Request for Additional Information  
Safety Evaluation  
Rare Element Resources, INC.

**RAI-1**

Figure RAI-1-1. Public exposure monitoring location (orange dot) at Demonstration Project [adapted from Figure 5 in RER Technical Report (RER, 2022a)].

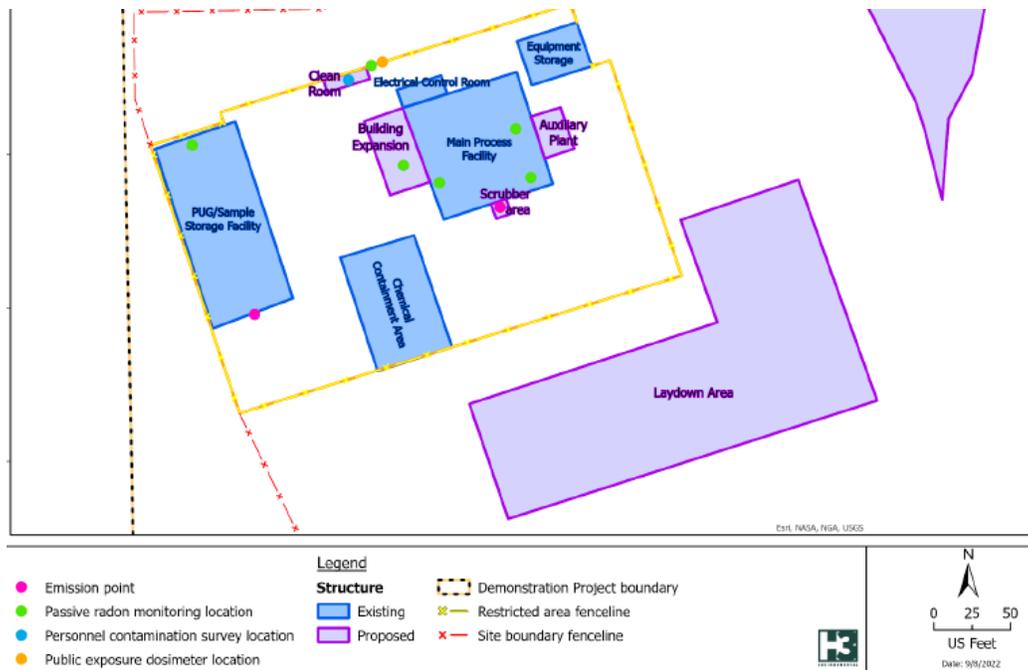
The applicant indicated that it would take measurements to demonstrate compliance with the public dose limits at one location at the restricted area fence. This monitoring location is shown in Figure RAI-1-1 below.

The NRC staff also notes that using a single measurement location close to a source, such as the restricted area fence (see Figure RAI-1-1) at the RER facility, may not yield useful data for

The applicant should provide a clear description and rationale of the location for determining compliance with the radiation dose limits for individual members of the public and a monitoring location that supports that determination. For example, it is not sufficient to demonstrate that a dose to a hypothetical receptor from operations is below regulatory requirements.

Figure RAI-1-2. Nearest residents (label A) and proposed public exposure monitoring location (label B) at Demonstration Project [adapted from Figure 6 in RER Technical Report (RER, 2022a)].

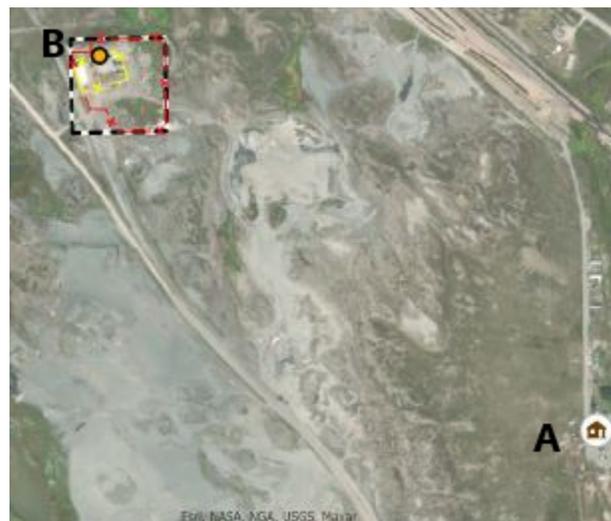
The applicant indicated the nearest residents were located as shown in Figure RAI-1-2 below (label “A”). The nearest resident (label “A”) is approximately 1.2 kilometers (km) (0.75 miles (mi)) from the proposed public exposure monitoring location (label “B”).

Figure RAI-1-3. Google Earth Pro representation of Upton wind rose and Demonstration Project [adapted from Map 4 in RER Environmental Report (RER, 2022a)].

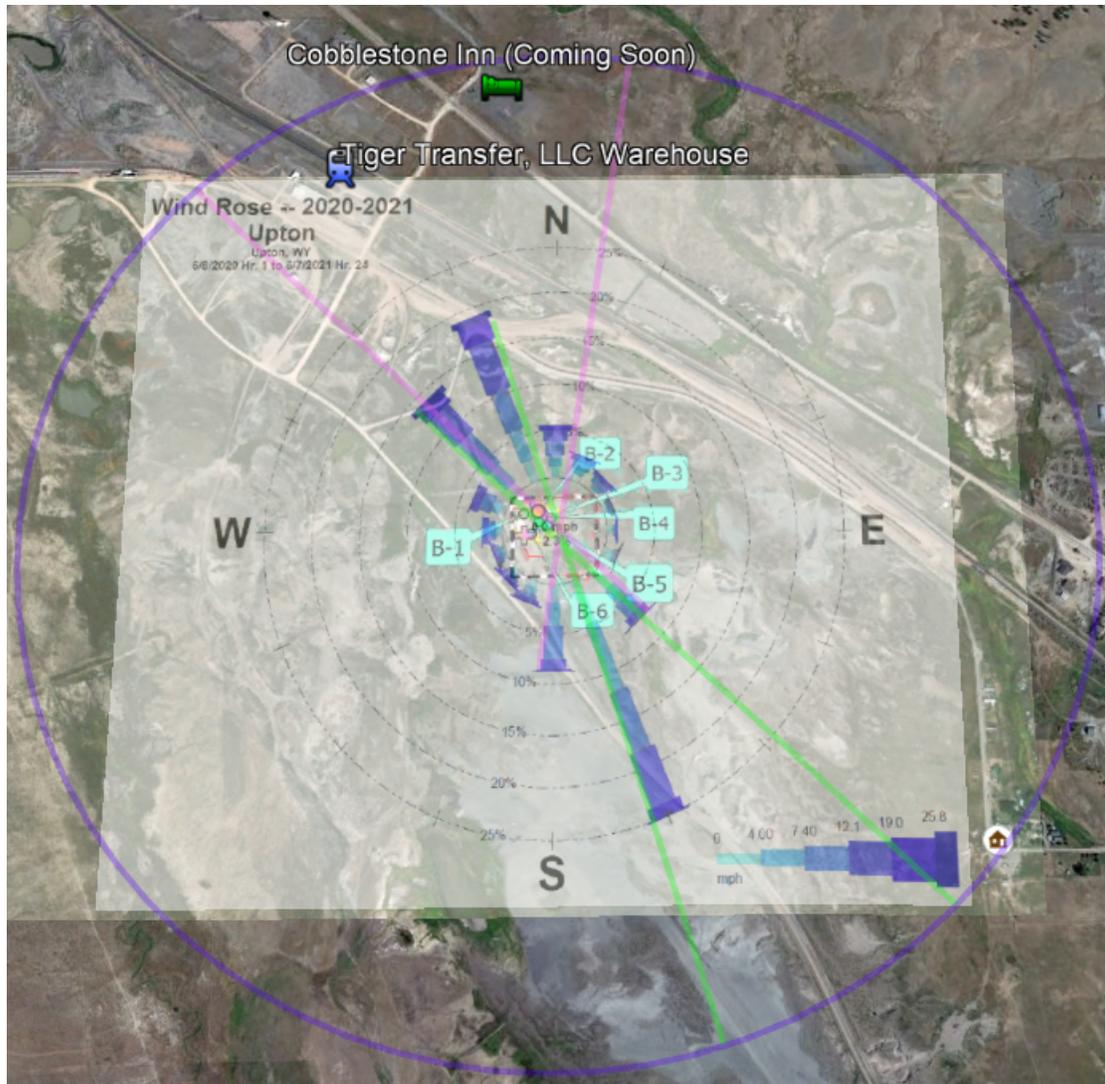
The NRC staff used Google Earth Pro to visualize downwind sectors based on a wind rose provided by the applicant (Figure 10 in the ER (RER, 2022a)). The wind rose and downwind sectors are shown in Figure RAI-1-3 below.

The NRC staff also evaluated other potential receptors in the area near the Demonstration Project that could be located downwind from the facility. The NRC staff identified two additional potential receptors. Tiger Transfer, LLC appears to be an operating business and the Cobblestone Inn appears to be a business in the construction phase. Both of these locations appear closer in distance to the Demonstration Project than the nearest residents identified by the applicant.

Figure RAI-2-1. Beta dose rate versus beta energy (5000 dpm/100 cm<sup>2</sup> surface contamination)

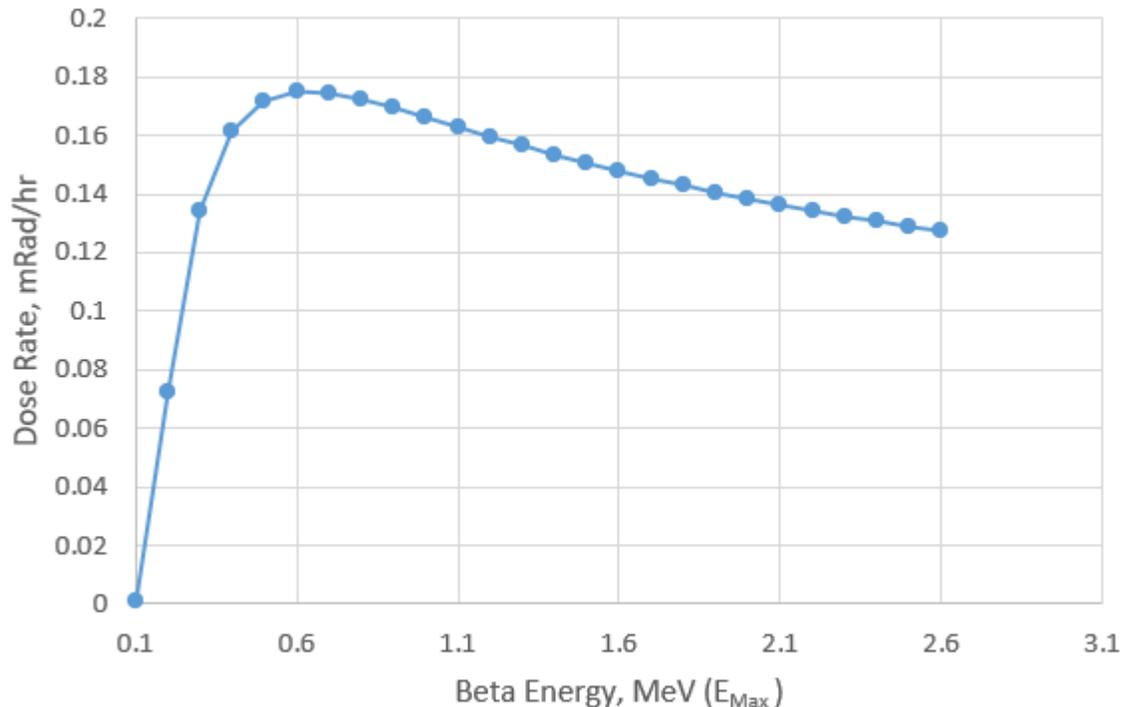
As Figure RAI-2-1 demonstrates, the dose rate is a maximum at around a maximum beta energy of 0.6 million electron volts (MeV) for the indicated contamination level and decreases with higher energies. This same trend is demonstrated in the applicant’s calculations, shown in Table RAI-2-1.

This trend is particularly noticeable for the case of higher surface contamination ( $C_a= 2.5$ , the gray shaded area in Table RAI-2-1). In the case of higher surface contamination, the highest energy beta particle (Bi-214,  $E_{Max}= 3.27$  MeV) results in a dose rate calculated by the applicant that is less than half of the dose rate from the lowest energy beta particle in Table RAI-2-1 (Actinium-228,  $E_{Max}= 2.08$  MeV). Therefore, the applicant’s approach does not appear to be conservative.

A reasonable calculational approach should consider all of the energy beta particles for the expected mixture of radionuclides at the facility and evaluated accordingly. In addition, Note 6 to Table M-2 in NUREG-1556, Vol. 12, includes gamma emitters. The applicant did not evaluate gamma emitters in addition to its dose rate estimate for beta emitters.

Figure RAI-2-2. Example alpha detector source calibration curve with the applicant's Po-210 calibration source added (adapted from Figure A-1 in NUREG-1507)

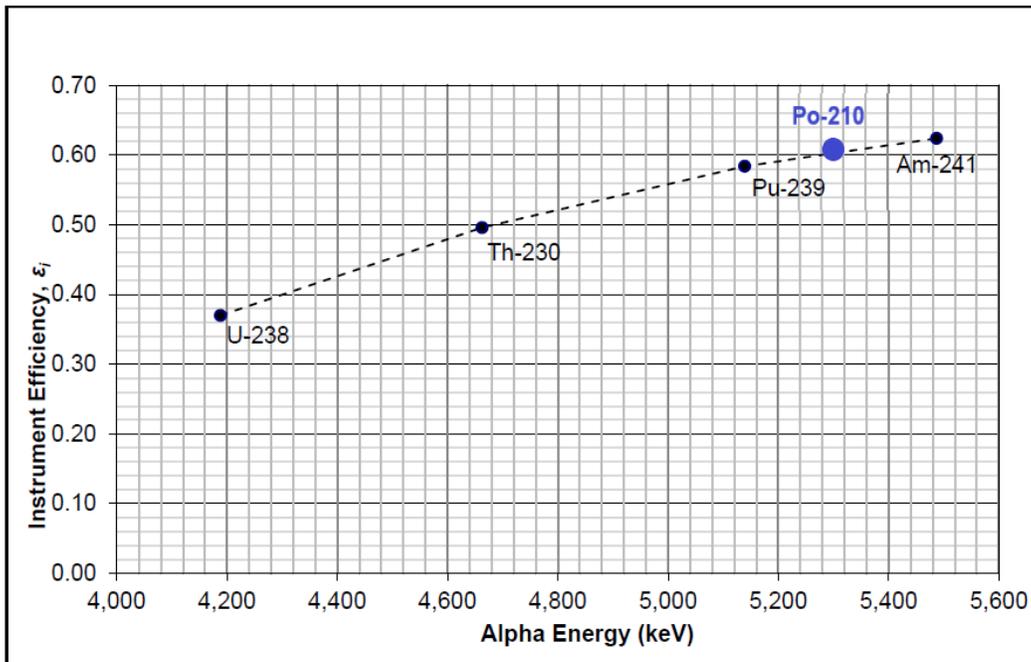
According to Table RAI-2-2., the applicant selected polonium-210 (Po-210) as its calibration source for determining instrument efficiency for alpha particles. Po-210 undergoes radioactive decay with a 5.3 MeV alpha particle. The NRC staff compared the Po-210 5.3 MeV alpha particle energy to the alpha particle energies in Table RAI 2-3 for the U-238 decay series. The NRC staff notes that the U-238, U-234, Th-230, and radium-226 (Ra-226) alpha particle energies are all below the Po-210 5.3 MeV alpha particle energy. Consistent with the guidance in NUREG-1507 (see the example in Table A-3), the instrument efficiency would be assigned zero for the U-238, U-234, Th-230, and Ra-226 alpha particles.

The applicant has the option of either choosing a lower energy calibration source or calculating a calibration curve with multiple alpha energy calibration sources. A typical calibration curve is demonstrated in Figure RAI-2-2. Actual alpha particle calibration curves for different alpha detection instruments are shown in Figures A-5 and A-11 of NUREG-1507 and have the same characteristics (i.e., higher instrument efficiency for higher energy alpha particles). The applicant did not address how this difference in energy response will be addressed in its calibration program.
